TRANS/WP.29/GRPE/2001/6
16 March 2001

World Forum for Harmonization of Vehicle Regulations (WP.29)

PROPOSAL FOR DRAFT CORRIGENDUM 2 TO REGULATION No. 110

(Specific components for CNG)

Fig. 1

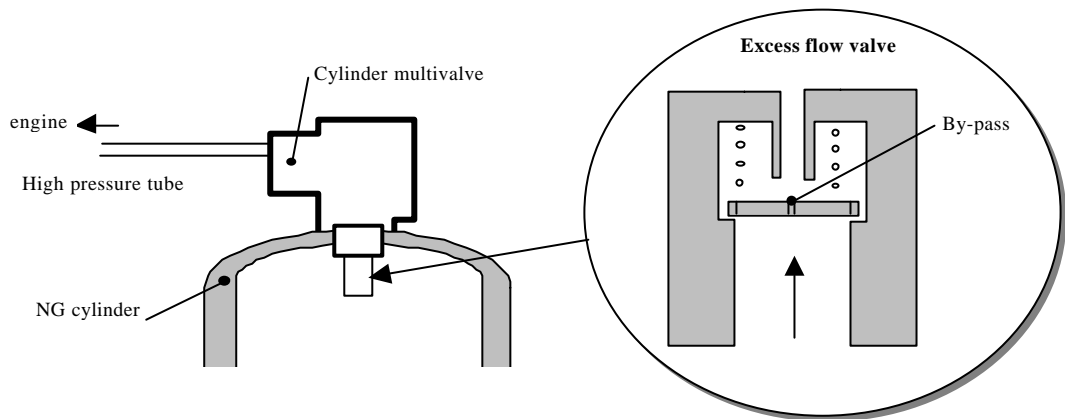
The parameter, which is selected to calibrate when the "excess flow" valve must close, is the differential pressure across the valve itself. The valve must close when the differential pressure exceeds the value corresponding to the maximum flow, which is required by the engine under normal operating conditions (full power and when starting a transient phase).

Some manufacturers make provision for a limited by-pass flow when the "excess flow" valve is fully closed, however, the by-pass flow through the valve must be limited for safety reasons according to guidelines that are to be provided for by Regulation No. 110.
